Service Bulletin

PRELIMINARY INFORMATION

Subject: Rough Harsh Ride

Models: 2015 GMC Sierra 1500 Denali
With Magnetic Ride Control Suspension (RPO Z95)
Vehicles Built Before 2/24/2015

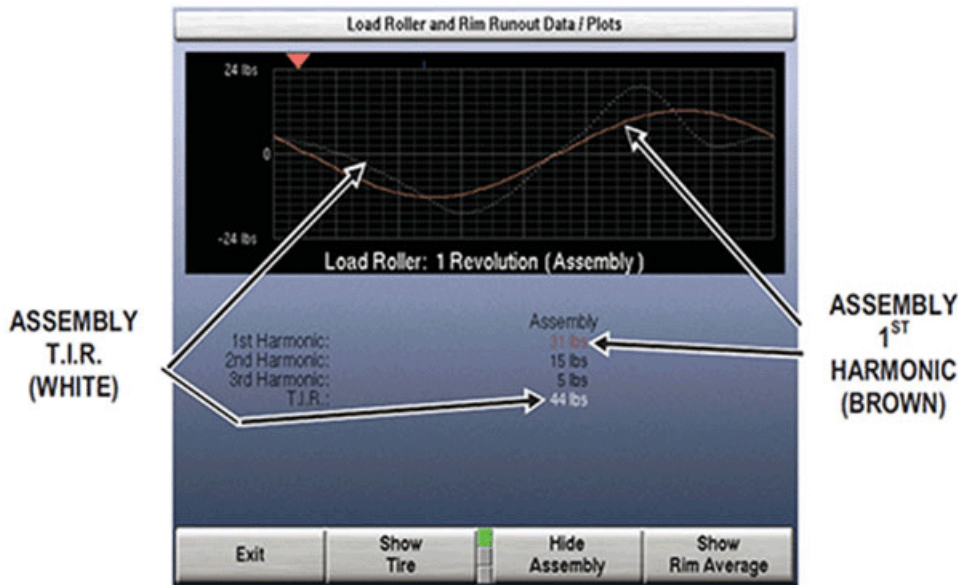
Following Z95 MR-related updates, re-evaluate the vehicle to ensure no other inputs/disturbances are present. If other inputs/disturbances are present, review the additional diagnostic tips in this PI and correct the remaining conditions:

- Tire and Wheel Assemblies
- Propeller Shaft
- Rear Drive Axle
